Office Action Summary	Application No. 10/564,226	Applicant(s) THOEMMES, FRANZ	
	Examiner Jason J. Boeckmann	Art Unit 3752

DETAILED ACTION

Examiners marked up figure 9

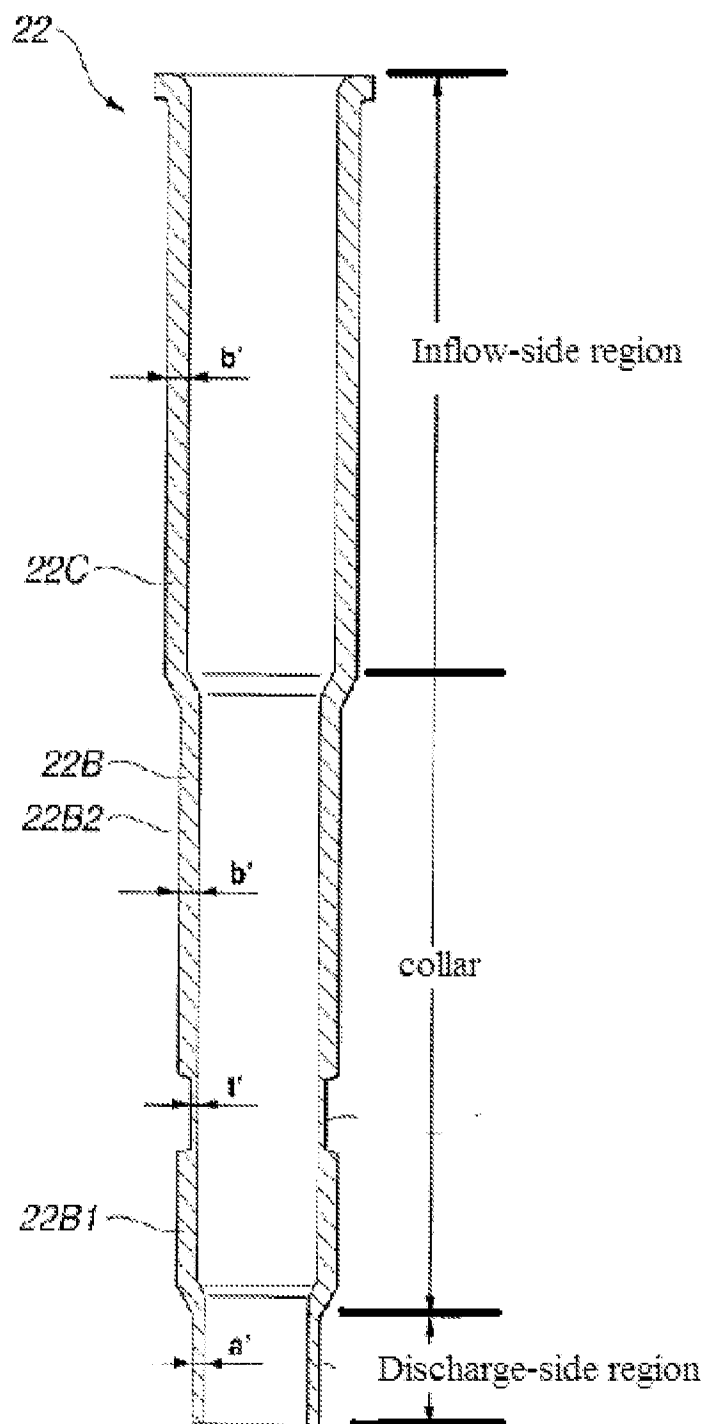
Kobayshi et al. shows a fuel injector (1) comprising; a valve needle (26) an armature (7C) forming an axially movable valve port together with the valve needle (7A),

a restoring spring (9) acting upon the armature, a magnetic coil (11) cooperating with the armature, a valve-seat body (5), a valve closure member (7B) which forms a sealing seat with the valve seat body and; a valve sleeve (22) surrounding the armature and the valve needle, a wall thickness of the valve sleeve varying across its axial direction (fig 9 below), wherein the wall the wall thickness of the valve sleeve decreases in a discharge direction of a fuel (figure 9), wherein an outer diameter and a radial cross section of the valve sleeve decrease between an inflow-side region and a discharge-side region on a color (figure 9), wherein the radial cross section and the wall thickness of the inflow-side region are constant from the collar to a location axially beyond the valve needle in a direction opposite the discharge direction of the fuel (figure 9 below); wherein the decreased radial cross section and decreased wall thickness of the discharge-side region are constant form the collar to a discharge-side end of the valve sleeve (see examiners marked up figure below).

Regarding claims 10 and 14, the wall thickness of the valve sleeve is about 0.5 mm in an inflow-side region and about 0.3 mm in a discharge-side region (paragraph 0067).
